## EAST COUNTY SUBSTATION PROJECT MINOR PROJECT REFINEMENT REQUEST FORM

<b>Date Submitted:</b>	12-19-13	<b>Request #:</b>	10	
<b>Date Approval Required:</b>	01-04-14	<b>Landowner:</b>	[This information has been redacted due to its confidential nature]	
<b>APN:</b>	[This information has been redacted due to its confidential nature]			
<b>Refinement from (check all that apply):</b>				
<input type="checkbox"/> Mitigation Measure	<input type="checkbox"/> APM	<input checked="" type="checkbox"/> Project Description	<input type="checkbox"/> Drawing	<input type="checkbox"/> Other
<b>Identify source (mitigation measure, project description, etc.):</b>				
<p>Page B-23, Page B-24, and Figures B-2, B-7, and B-8 in Section B. Project Description of the Final Environmental Impact Report/Environmental Impact Statement (EIR/EIS) for the East County Substation Project (Project) describe and depict the alignment of the 138 kilovolt (kV) Overhead Transmission Line between Carrizo Gorge Road and Tule Jim Lane. In addition, changes due to the final design of the 138 kV Overhead Transmission Line were discussed and evaluated in Minor Project Refinement (MPR) request #6, which was approved by the Cali

**Attachment B: Overview Map  
SP-63 and SP-64**

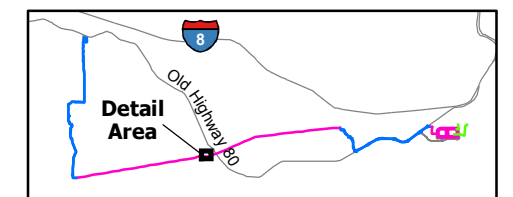
<b>Describe refinement being requested (attach drawings and photos as needed):</b>					
<p>The 138 kV Overhead Transmission Line alignment was described on pages B-23 and B-24 in Section B. Project Description and depicted on Figures B-2, B-7, and B-8 in Section B. Project Description of the Project's Final EIR/EIS and the approved MPR request #6. This MPR request proposes to improve the access road at SP-63 and to modify the maintenance pad and access road for SP-64. The SP-63 access road improvements will result in an increase in permanent impacts of approximately 0.02 acre. The changes at SP-64 will result in a reduction in temporary impacts by approximately 0.03 acre and a reduction in permanent impacts by approximately 0.02 acre. Therefore, the proposed refinements will have no net change in the overall permanent impacts of the Project and will decrease the overall temporary impacts of the Project. Attachment B: SP-63 and SP-64 Overview Map depicts the differences in permanent and temporary impacts due the final design of the SP-63 access road and SP-64 pad site and access road described in this MPR request. The existing conditions of the refinement areas are shown in Attachment E: Photographs. The activities associated with the construction and utilization of the refinement areas will occur in the same manner as described in the Final EIR/EIS for construction, operation, and maintenance of the Project.</p>

<b>Provide need for refinement (attach drawings and photos as needed):</b>					
<p>The minor refinements described in this MPR request are required to accommodate the equipment needed to construct the transmission line, as well as to avoid a recently discovered environmentally sensitive area (ESA). The requested addition of a permanent impact area to the access road to SP-63 is required to accommodate access for all construction vehicles during construction of SP-63. The refinements to the SP-64 maintenance pad and access road are required to avoid the recently discovered ESA. The refinements, depicted in Attachment B: SP-63 and SP-64 Overview Map were included in previous resource surveys conducted for the Project, as shown in Attachment C: Refinement Area Survey Results Map.</p>					
<b>Date refinement is expected to be implemented:</b>				01-06-14	
<b>SDG&amp;E Approvals</b>					
<b>Title</b>	<b>Name</b>	<b>Approval Initials</b>	<b>Date</b>	<b>Conditions (see attached)</b>

Attachment C: Refinement Area Survey Results Map

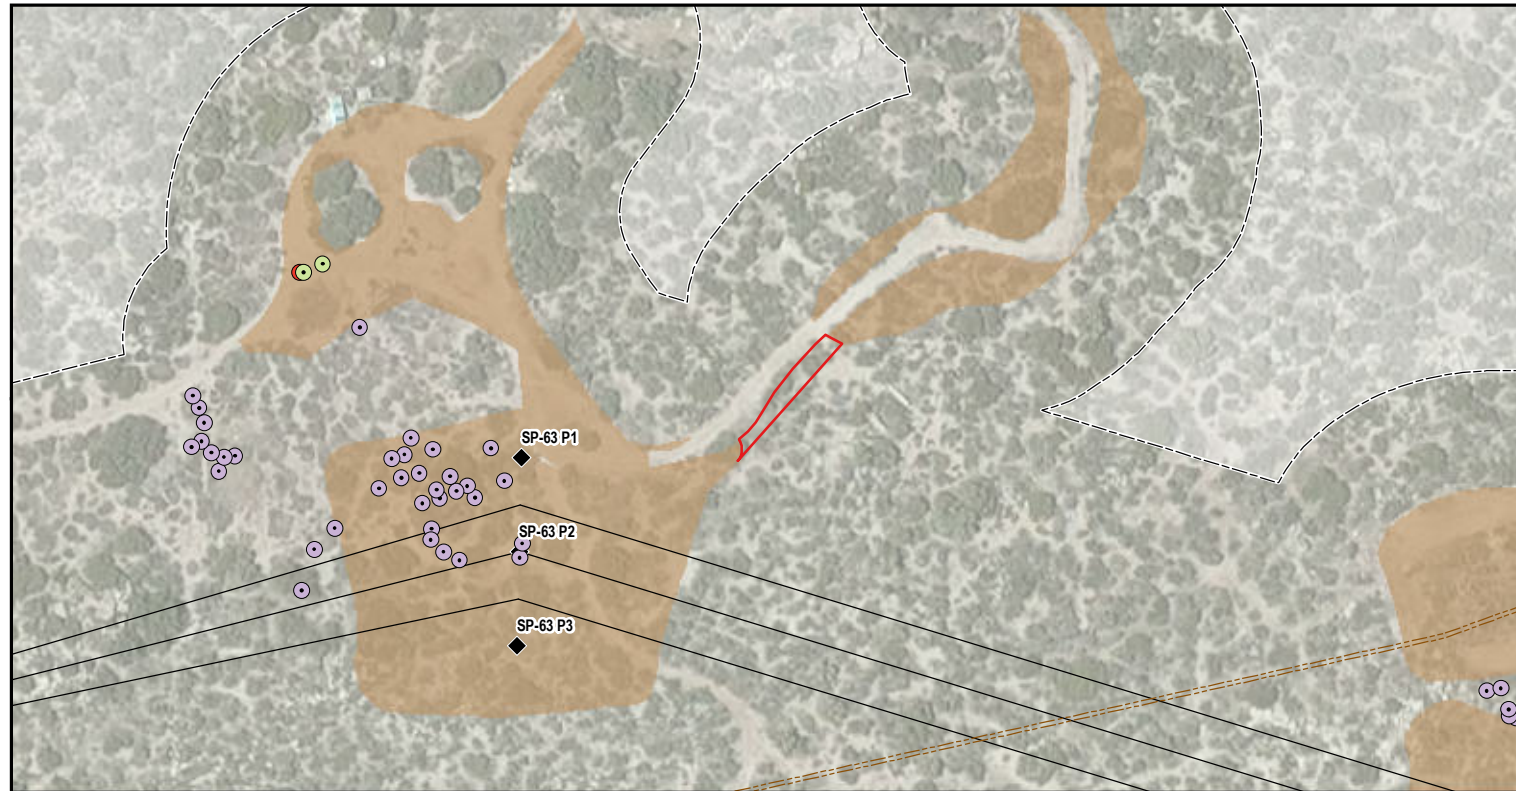
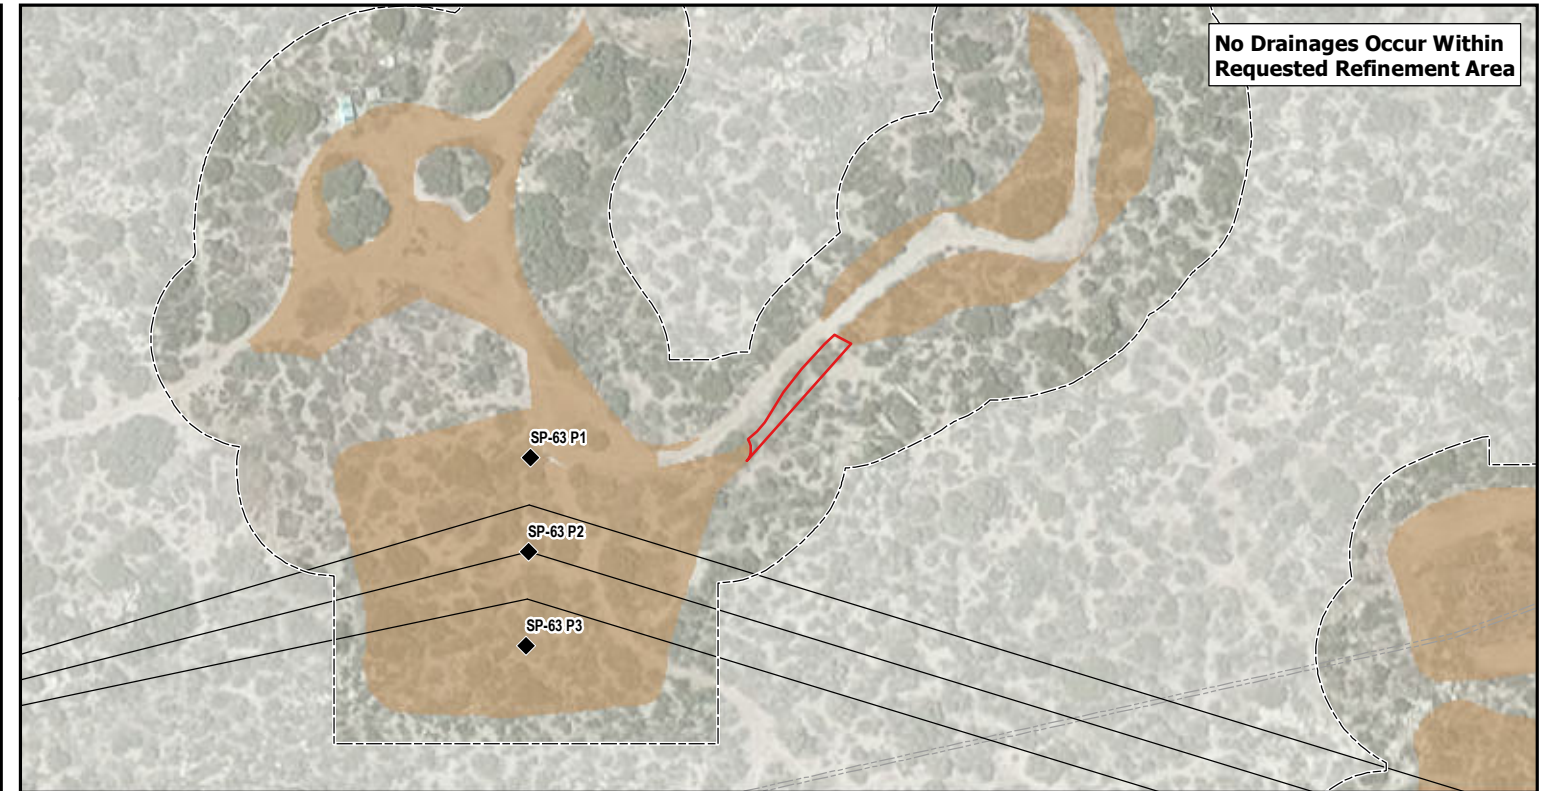
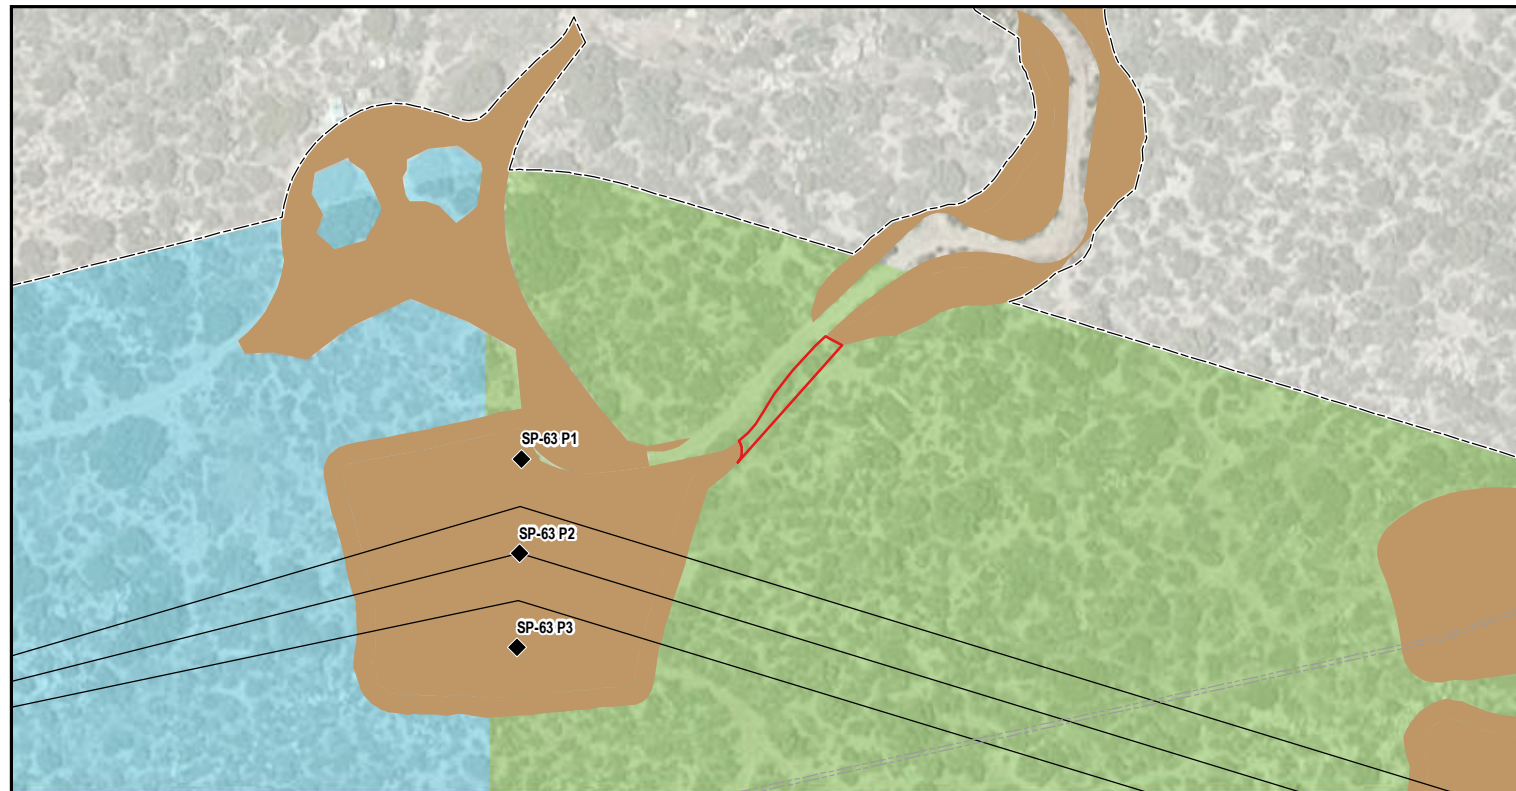
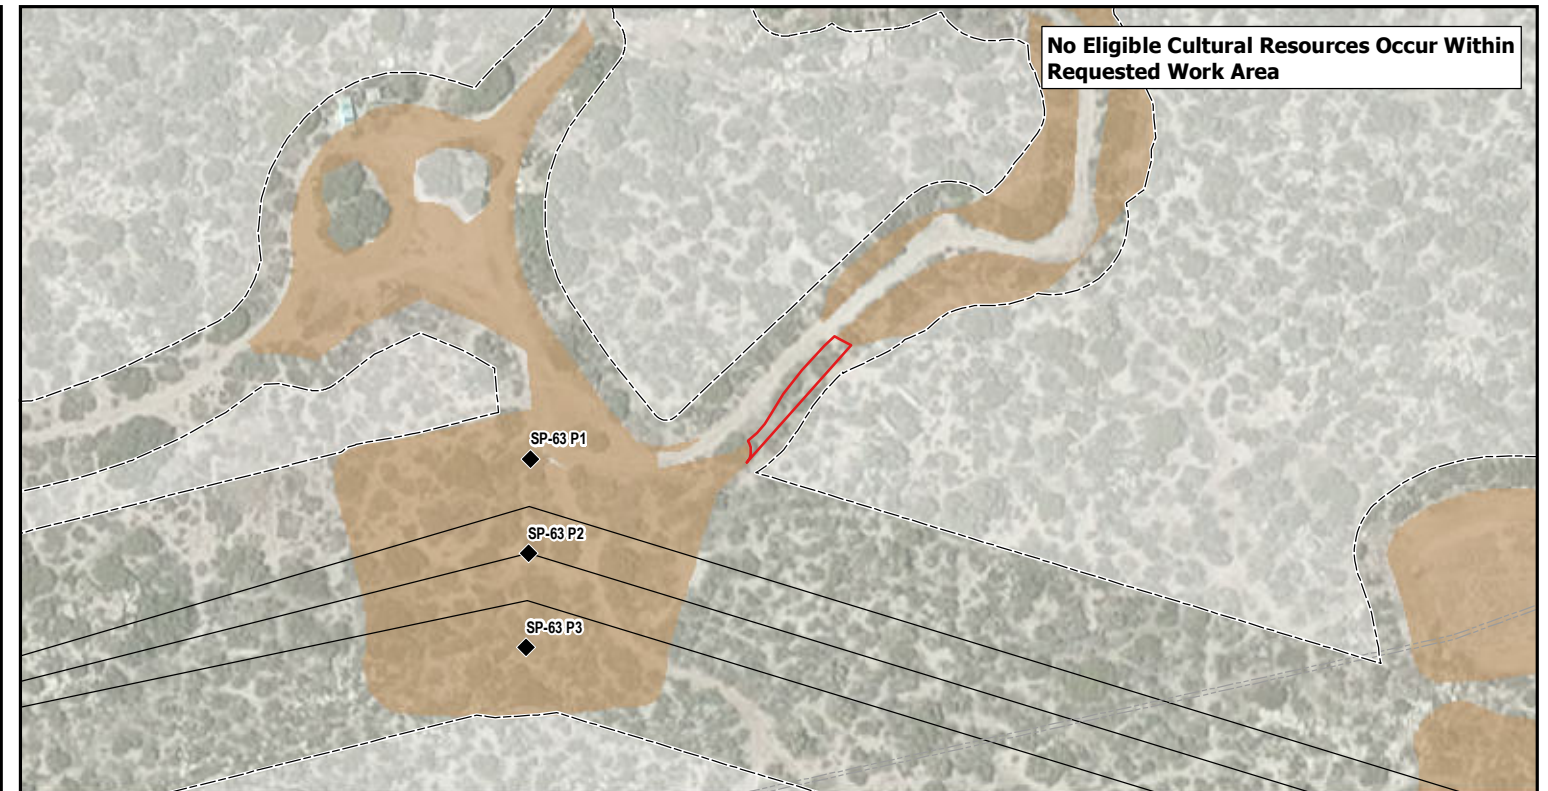
Water Resources	<p><i>No Change.</i> The approved 138 kV Overhead Transmission Line alignment, including the SP-63 and SP-64 sites, was included in the initial jurisdictional surveys conducted for the Project. In addition, supplemental jurisdictional drainage surveys were conducted at the SP-63 and SP-64 sites from April 8 to 11, 2013. Data collected for each drainage feature was based on the 2005 U.S. Army Corps of Engineers (USACE) Regulatory Guidance Letter No. 05-05 Ordinary High Water Mark Identification and the 2008 Field Guide to the Identification of the Ordinary High Water Mark in the Arid West Region of the Western United States. No drainages are located within the proposed refinement areas. Attachment C: Refinement Area Survey Results Map depicts the surveyed areas.</p> <p>The refinements will not degrade water quality due to erosion, sedimentation, or spills of potentially harmful materials or interfere with the implementation of the Linear SWPPP to reduce erosion and sedimentation and prevent non-storm water from entering surface water or groundwater. No change in the amount of impervious surface will occur because the additional permanent impact area within the access road to SP-63 will not be paved. Water use necessary for construction of the Project was analyzed on a Project-wide basis, and it is not anticipated that the minor changes in areas of potential ground disturbance, which are due to the proposed refinements, will result in an increase in water use during construction of the 138 kV Overhead Transmission Line. The refinements to the access road to SP-63 and the access road and maintenance pad at SP-64 will not increase impacts to California Department of Fish and Wildlife (CDFW-) or USACE-jurisdictional drainages.</p> <p>The refinement areas will be constructed using the same construction practices as those described in the Project's Final EIR/EIS. The BMPs provided in the Linear SWPPP will be implemented to reduce the potential for storm water runoff, erosion, sedimentation, and significant alterations to drainage patterns.</p> <p>As described in the preceding discussion, the refinements will not result in a new, significant impact nor a substantial increase in the severity of a previously identified</p>
